P.O.A.D.P. PLAN  
 for  
 DAVENPORT 207

Re: Davenport 207

POADP # 614

The City Staff Development Review Committee has reviewed Davenport 207 Subdivision Preliminary Overall Area Development Plan # 614. Please find enclosed a signed copy for your files. Although your plan was accepted, please note the following:

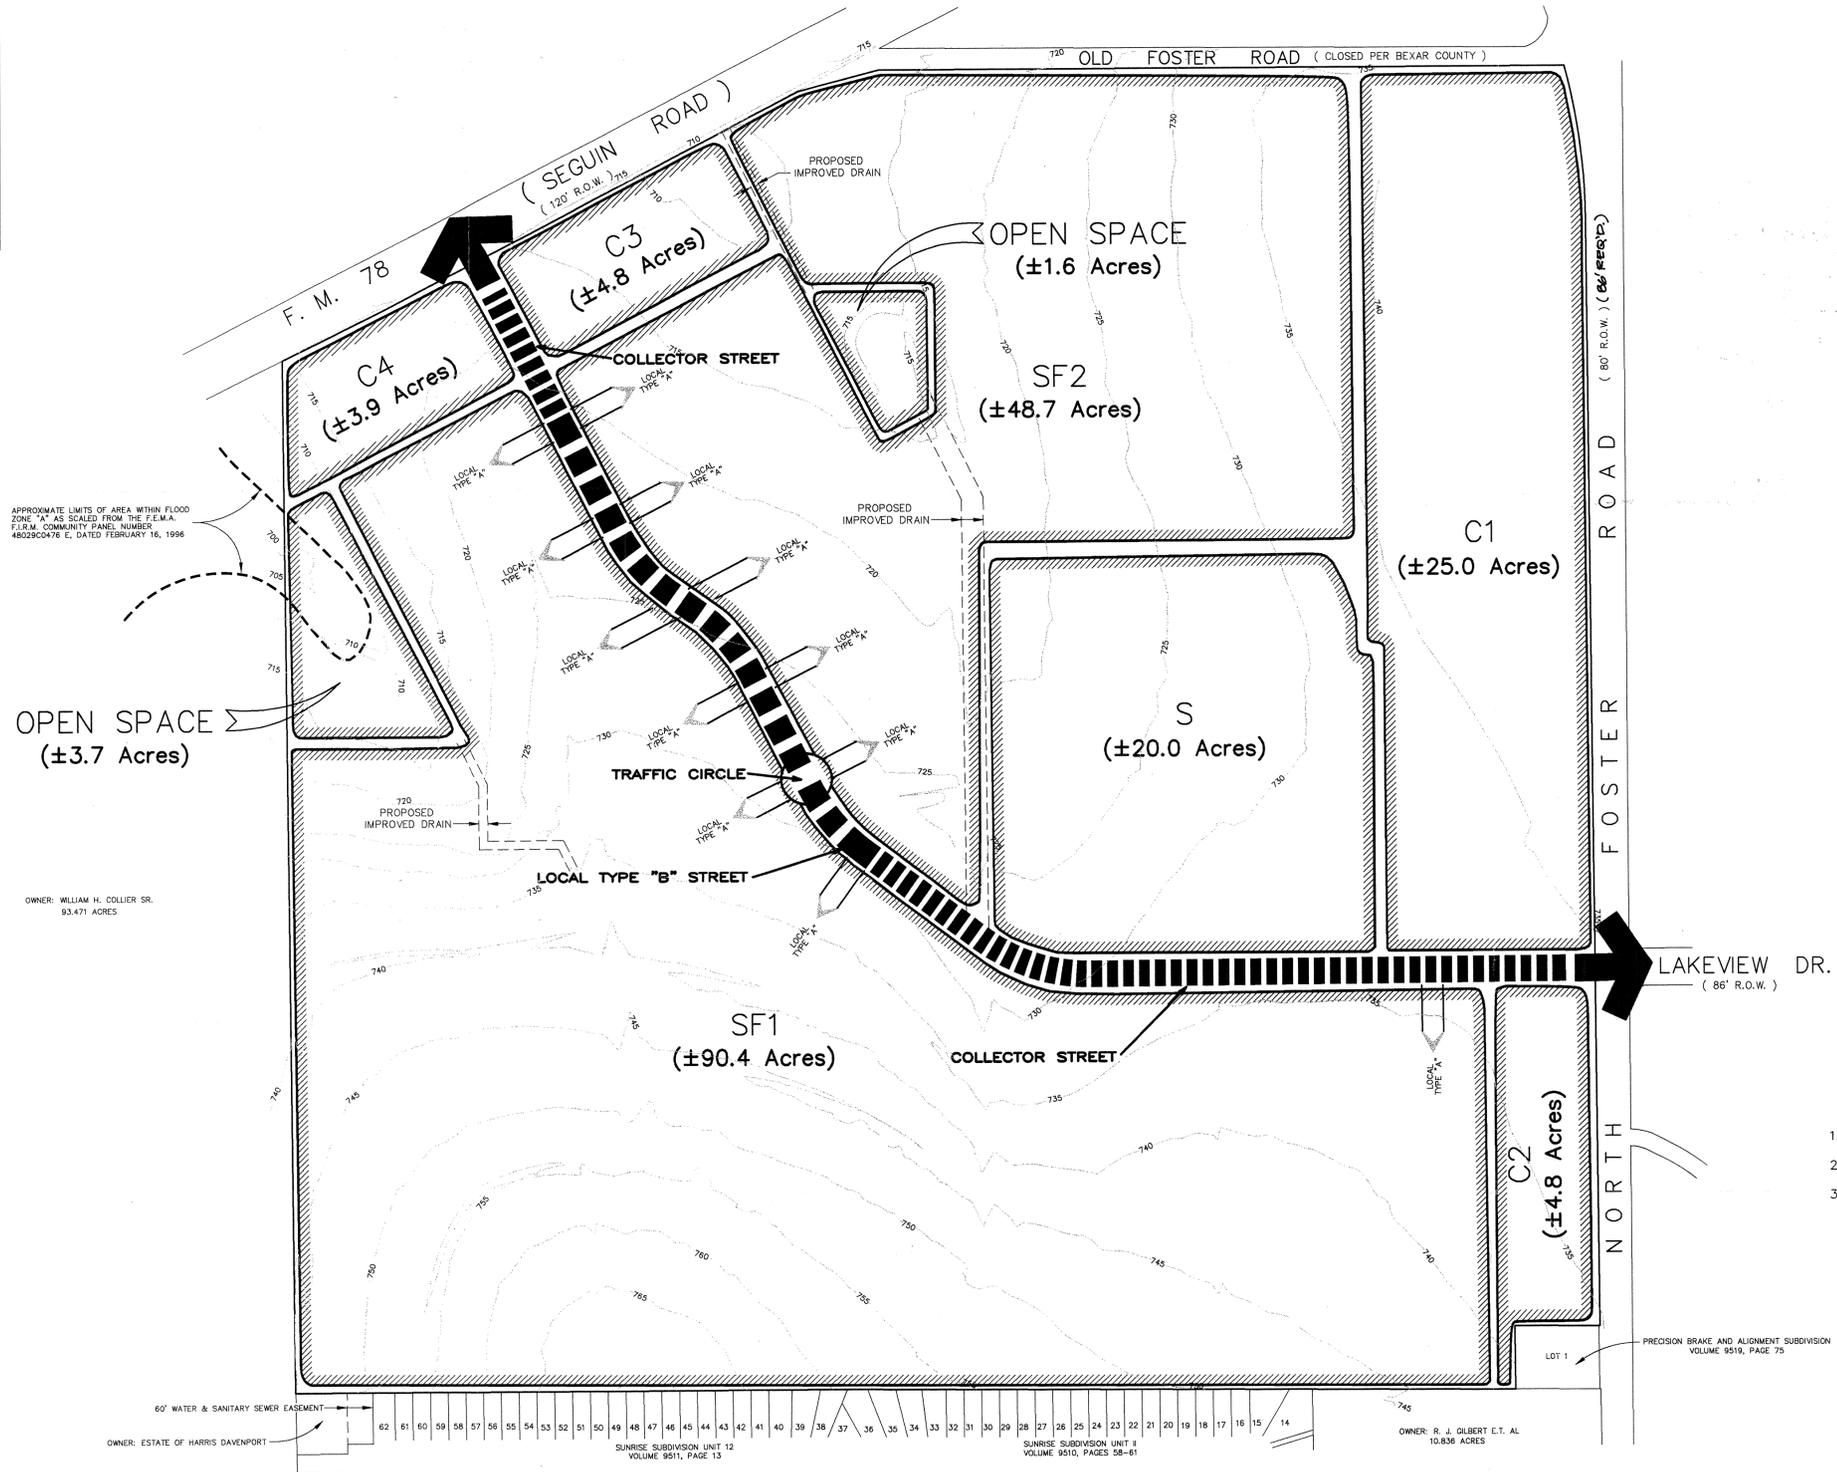
- Based on the topography, a Flood Plain Study and drainage review will probably be required during the platting process.
- Access and R.O.W. issues along State facilities will need to be resolved with the Texas Department of Transportation (TXDOT). For information about these requirements you can contact TXDOT at 615-5814.
- This development will need to comply with tree preservation ordinance #85262. For information about these requirements you can contact Building Inspections at 207-7102.
- It will be expected that you will plat all of the property depicted in your POADP, to include: floodpains, drainage areas and open space.
- I would encourage you to work closely with the school district, so that they can plan accordingly.
